Job name: Ford Airfield

Job No: C85228

Note No: C85228-JNP-92-XX-RP-C-1004

Subject: Ford Airfield – Updated outline planning drainage strategy following meeting Arun District Council (ADC) Drainage Department on Tuesday 25 May 2021

Drawing No. C85228-D100	Rev
	G

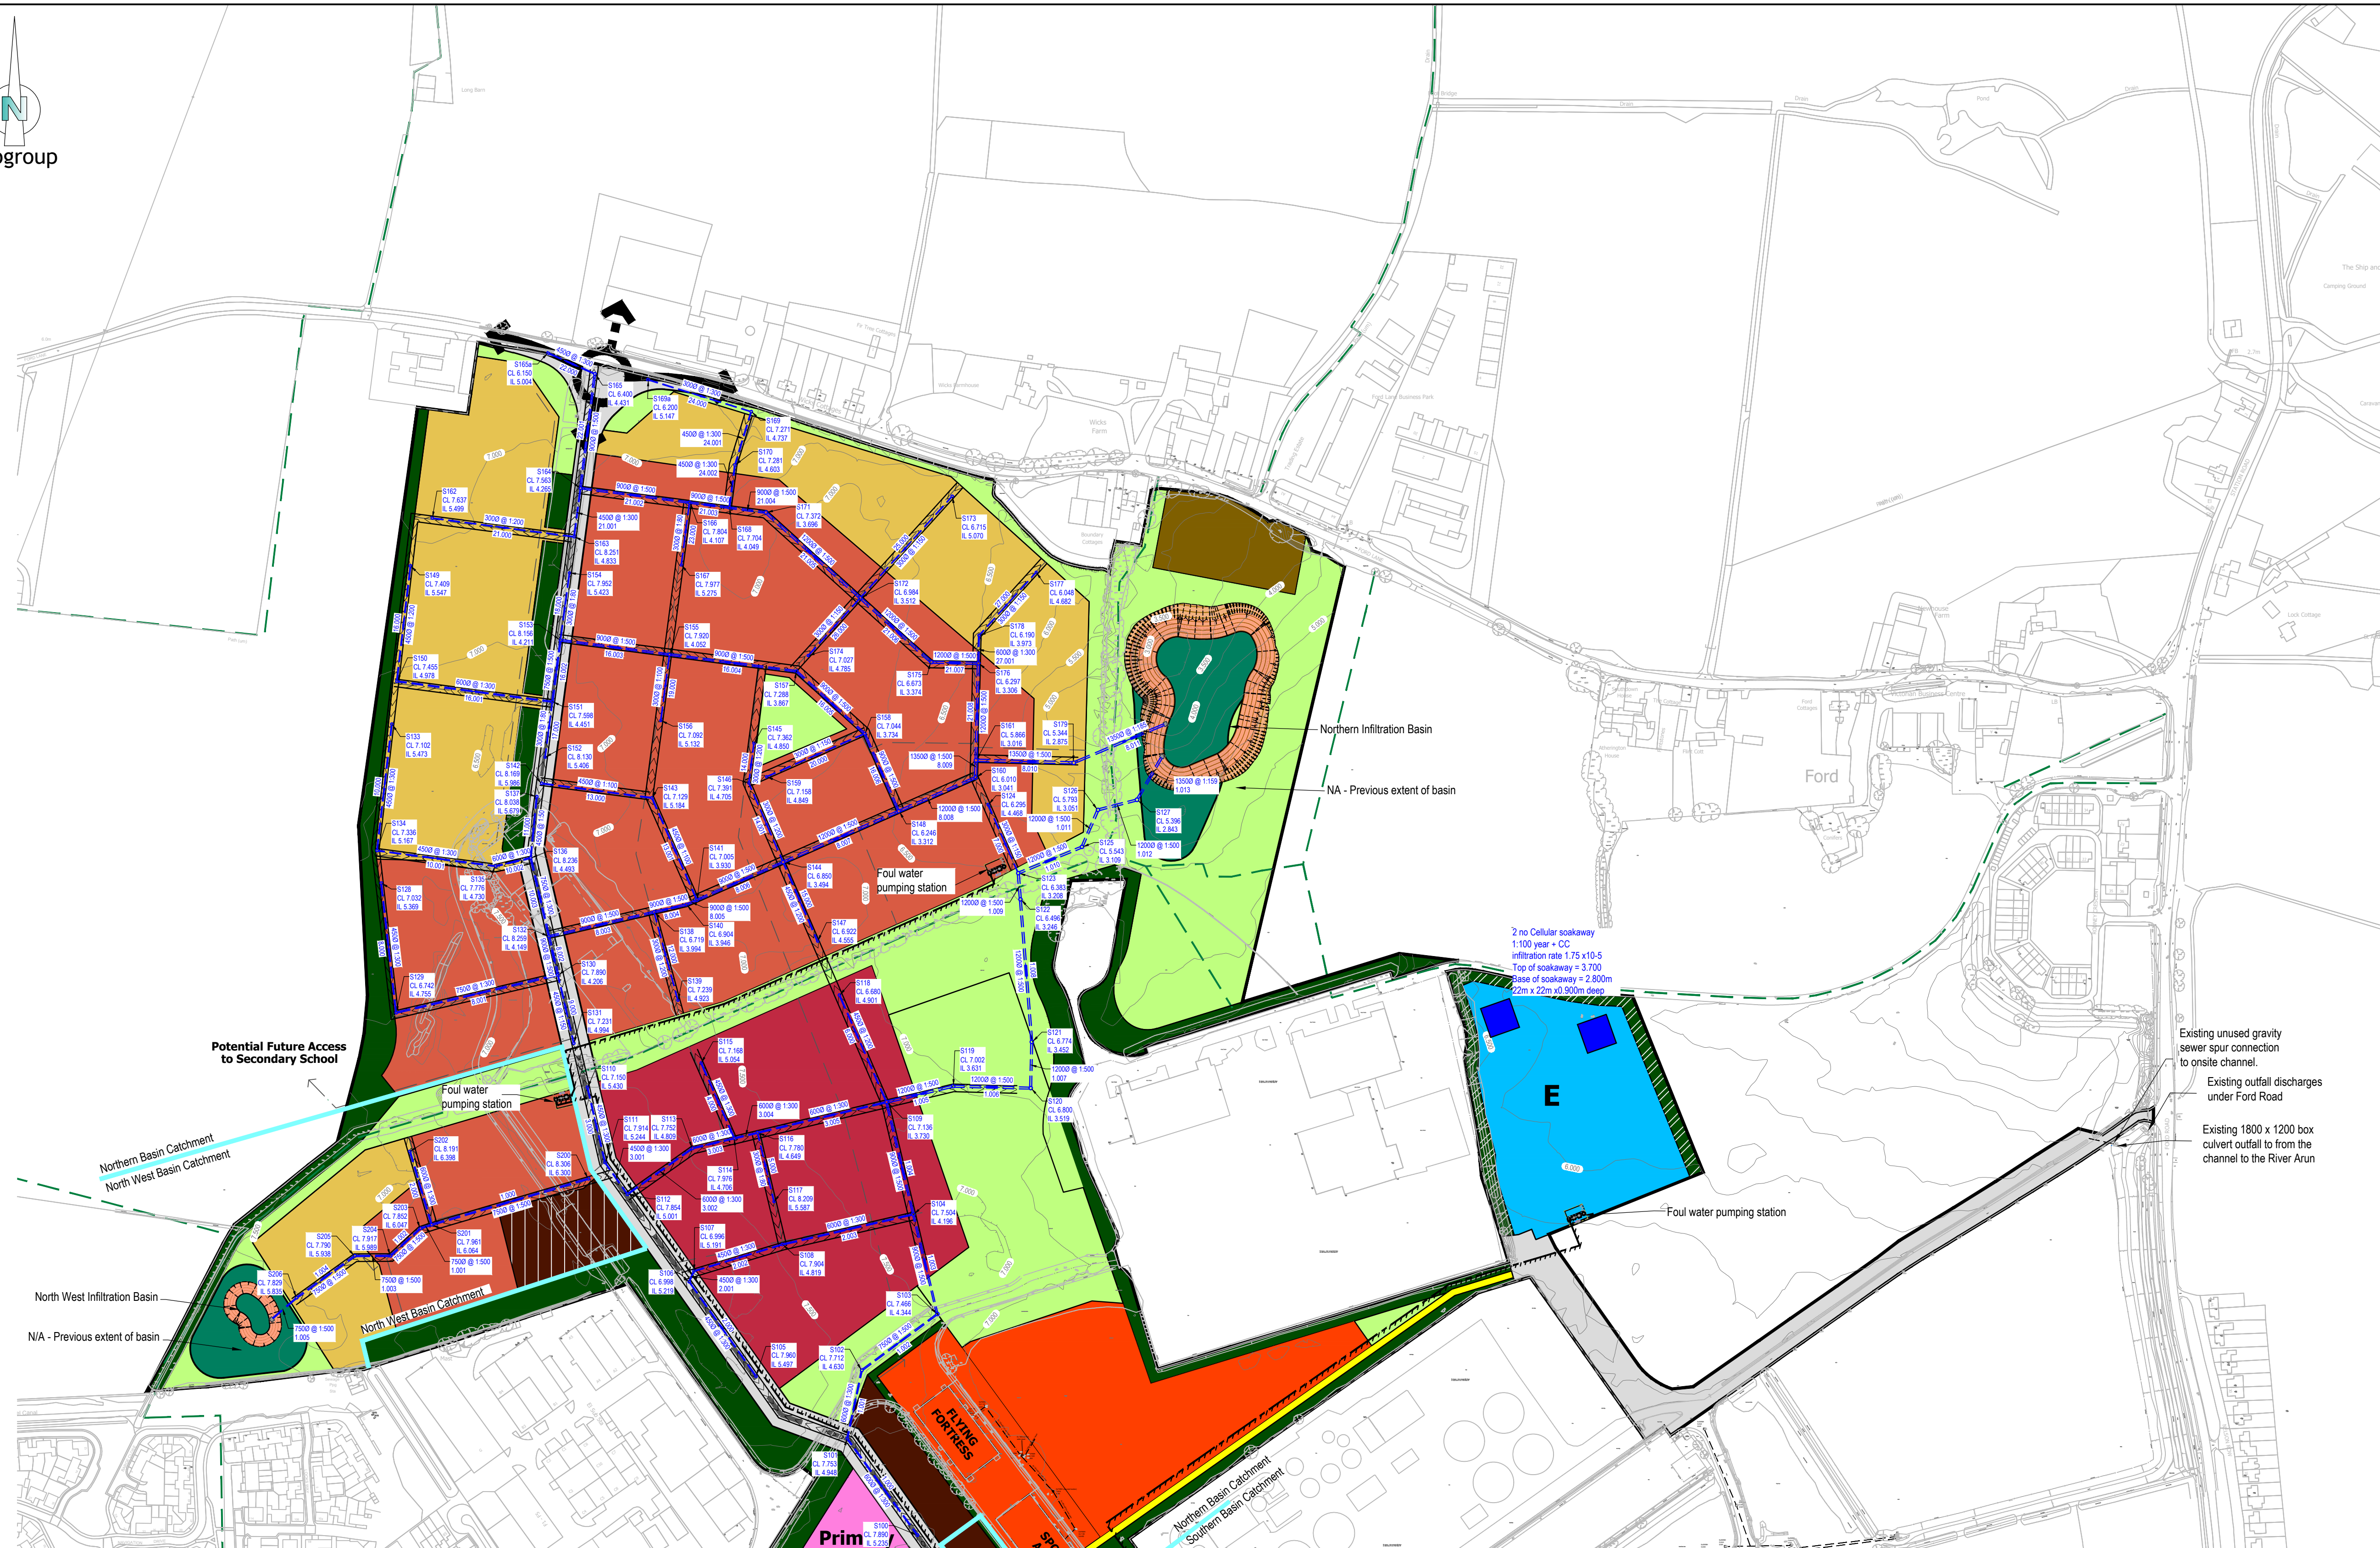
- 2.5 This was discussed with ADC during the meeting held on 25 May 2021. It was agreed that the information provided supports the use of infiltration drainage in the Northern Parcel, North-West Parcel and Employment Zone.

- 2.6 We agreed that water quality improvement would be addressed by providing permeable paving and a sediment forebay as part of the infiltration basin design and this would form part of reserved matters design.

- 2.7 ADC also required additional winter soakaway and groundwater level monitoring to be carried out at the proposed location of the infiltration basin.

- 2.8 It was agreed the infiltration solutions provided for the north of the site are satisfactory to grant outline planning.

The size, shape and location of the basins and underdrain swales are indicative and are subject to further design to ensure landscape and ecological benefits. This will be carried out for detailed approval on a phase by phase basis at reserved matters stage.
